File # CUP2021-000479

Conditional Use Permit Review

Request: Conditional Use/Site Plan Approval for a Multi-Tenant Industrial Office Building

ATTACHMENT #4 REVIEWING AGENCIES RESPONSE

LS01

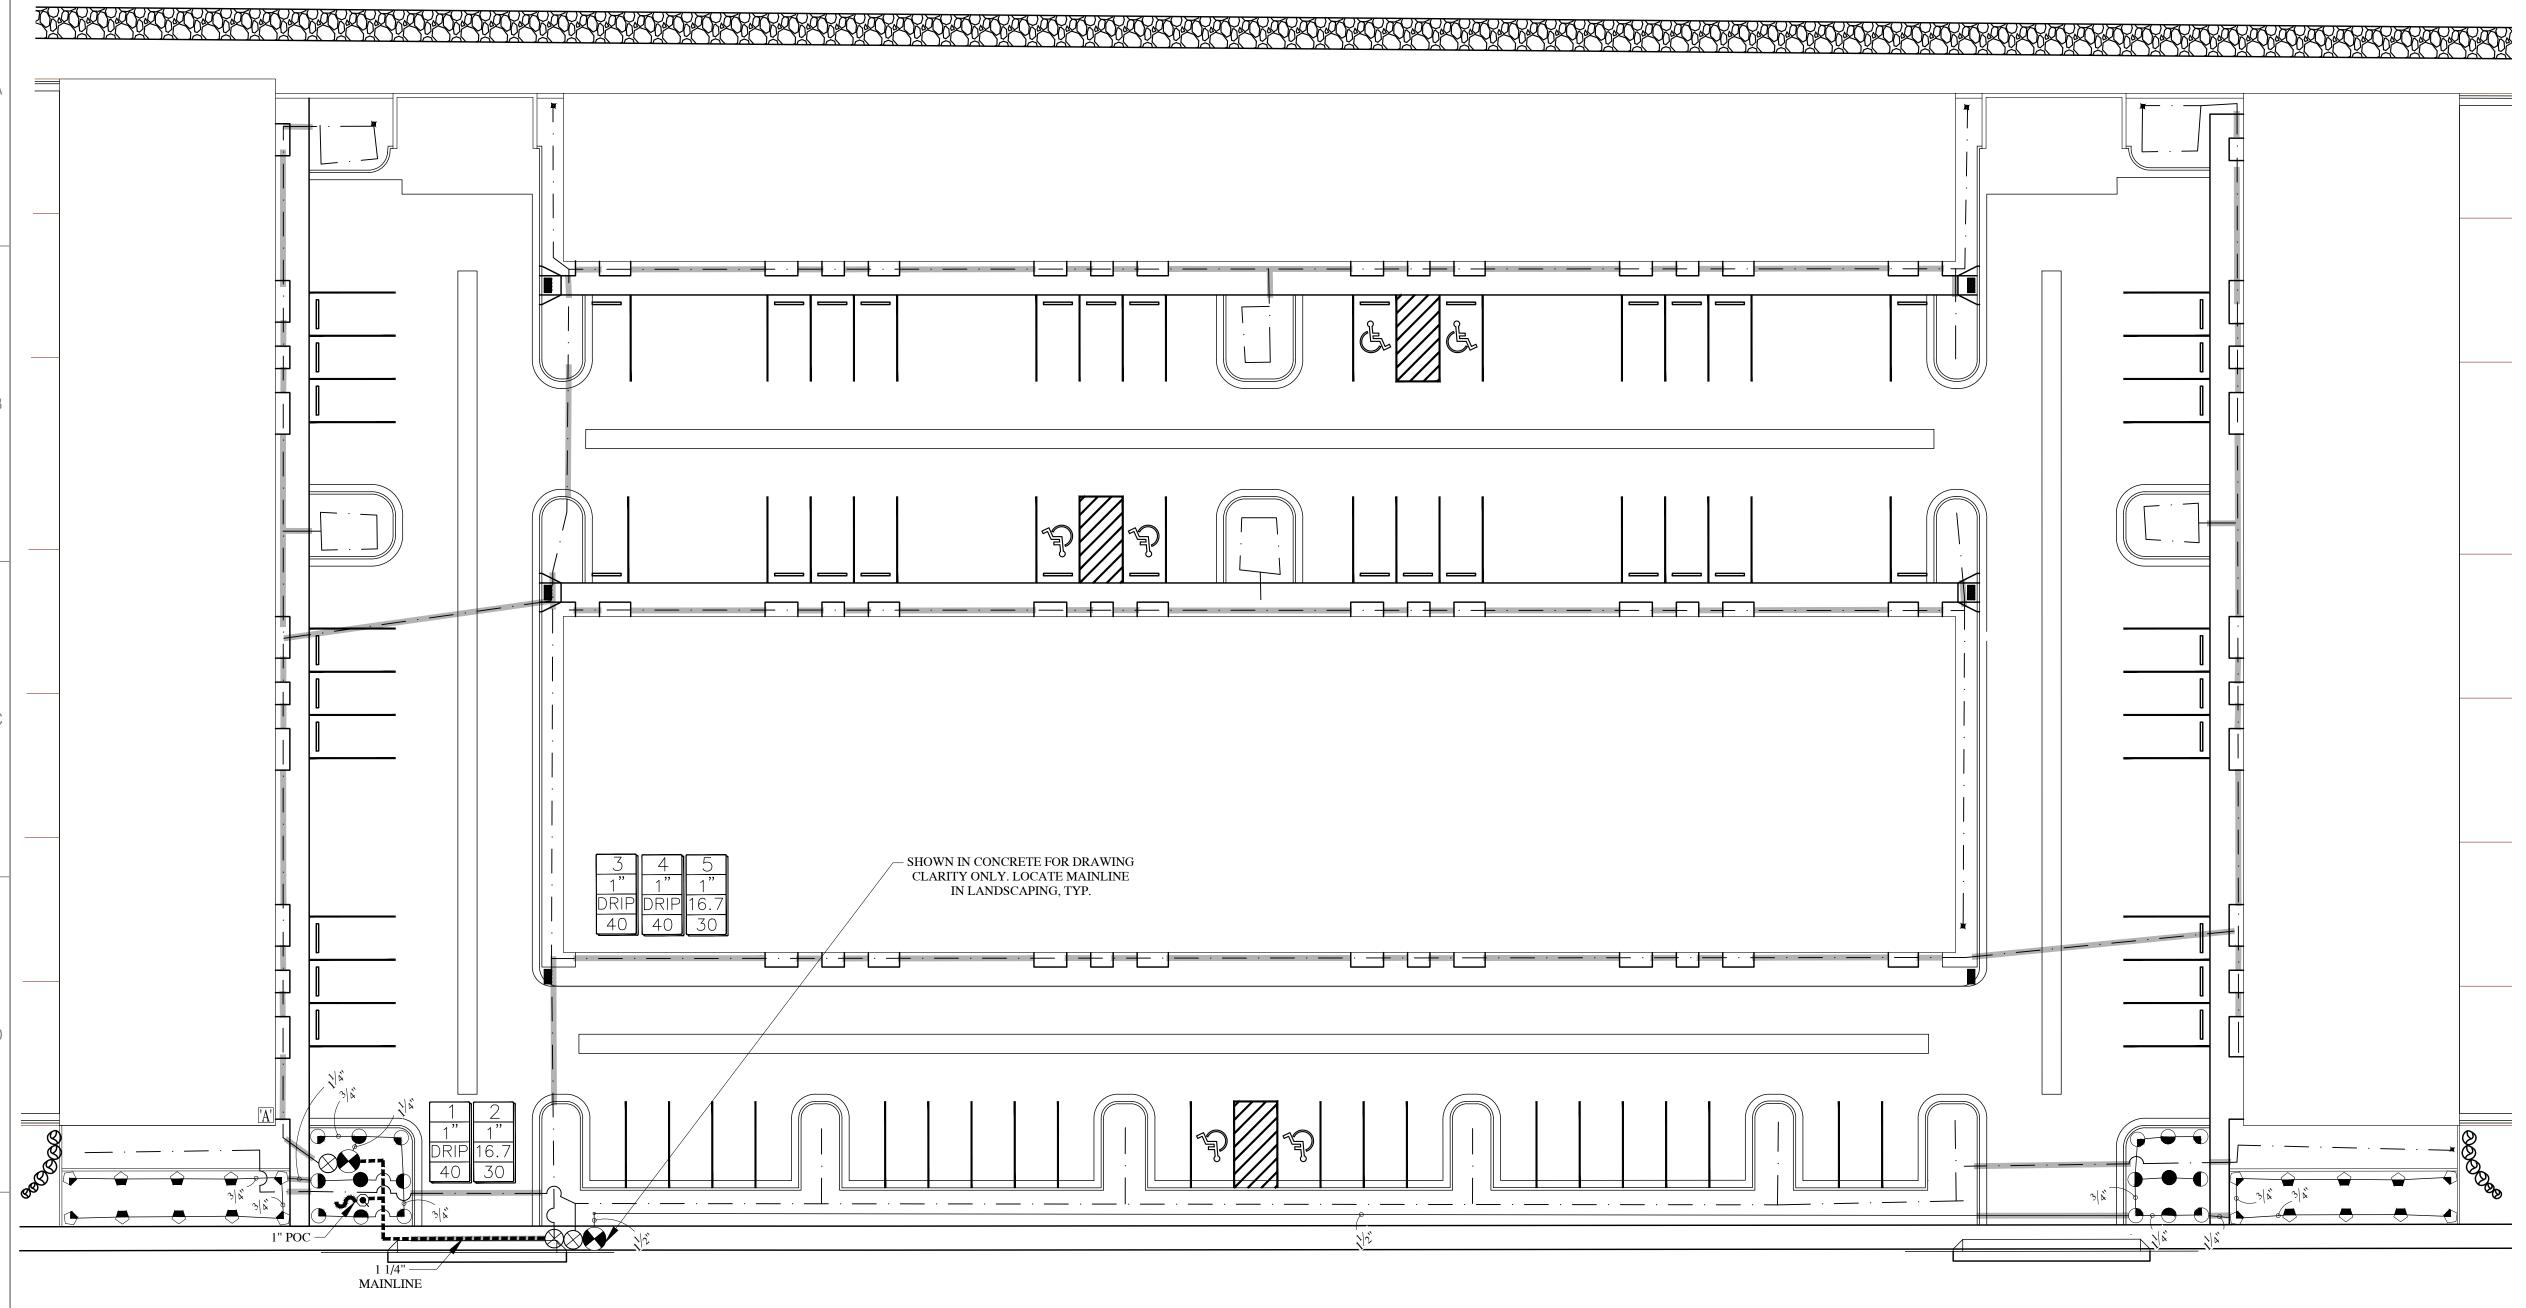
- 1. Landscaped peninsulas must be 9' wide, curb face to curb face. The peninsulas between spaces 1-24 are only 8' wide.
- 2. Parking spaces must be 9' wide x 18' deep. Provide at least one parking space with dimensions to demonstrate compliance.

- 3. A comprehensive signage package must be submitted for technical review.
- 4. One shade tree and four shrubs must be located within each landscape planter island and peninsula. Many of the islands/peninsulas meet this but not all.

- 4. 40% of the trees and shrubs must be coniferous/evergreen. Please include a calculation demonstrating compliance on the revised plan.
- 5. Lawn area can't exceed 20% of the landscaped area. Please include a calculation demonstrating compliance.

- 6. Mulch areas must be 3-4 inches deep. Please include a note on the revised plan indicating this.
- 7. Landscaped areas shall be provided with a WaterSense labeled smart irrigation controller which automatically adjusts the frequency and/or duration of irrigation events in response to changing weather conditions. All controllers shall be equipped with automatic rain delay or rain shut-off capabilities. The specs for the controller on the irrigation plan don't seem to include an automatic rain delay/shutoff capability.
